Addendum 6 to the CP-HPS2 2010 FEIR

Addendum Date: October 1, 2019
Case No.: 2007.0946E
Project Title: Candlestick Point–Hunters Point Shipyard Phase II
Development Plan Project
EIR: Certified June 3, 2010
Project Sponsor: CP Development Co., LLC
Lead Agency: Office of Community Investment & Infrastructure
OCII Staff Contact: José Campos – 415.749.2554
jose.campos@sfgov.org
City Staff Contact: Joy Navarrete – 415.575.9040
joy.navarrete@sfgov.org

Addendum 6 to the CP-HPS2 2010 FEIR
HARNEY WAY OFF-SITE MODIFICATION (SEGMENT 1 OF 3)

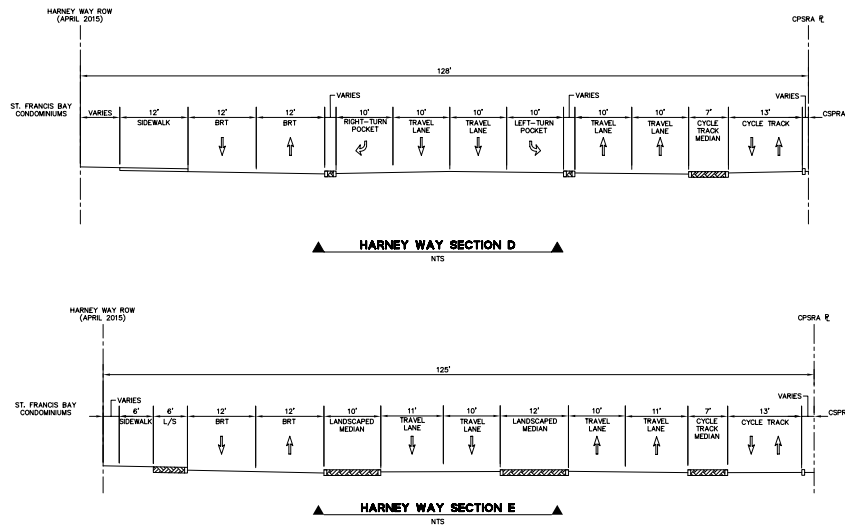
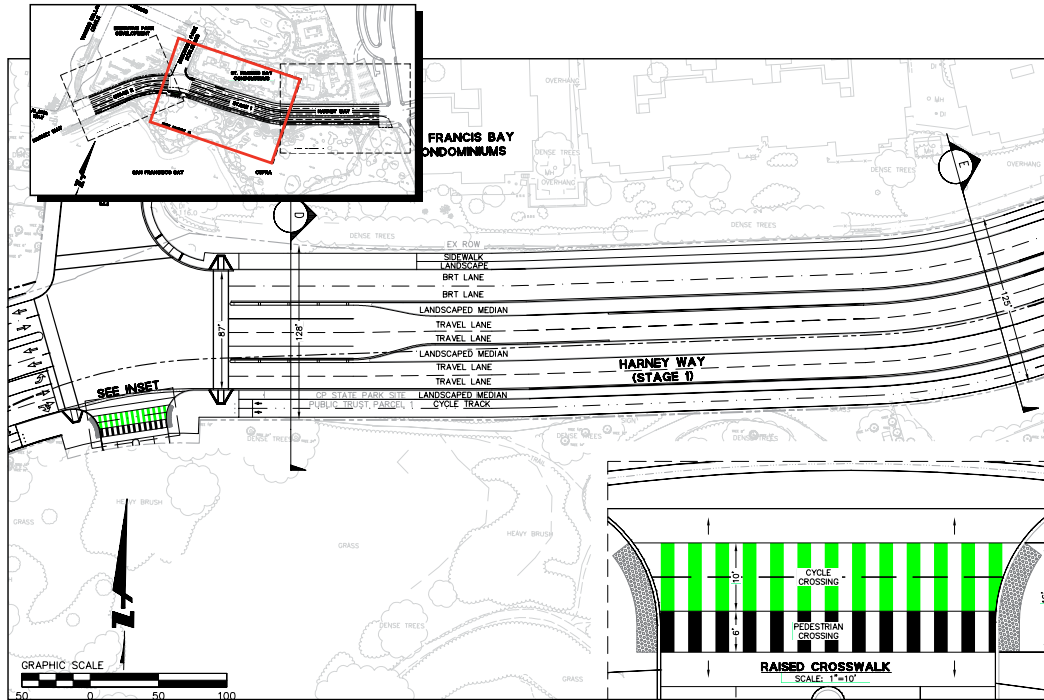
The changes to the off-site segment of Harney Way have resulted from two primary modifications. First, there have been modifications to driveway access to the State Park. Second, an interim BRT route via Executive Park Boulevard would be provided in advance of the Geneva-Harney BRT. Therefore, the 2019 Modified Project Variant proposes to revise the design of an off-site segment of Harney Way, as illustrated in Figure 16a (Harney Way Off-Site Modification (Segment 1 of 3)) through Figure 16c (Harney Way Off-Site Modification (Segment 3 of 3)), pp. 68 to 70.
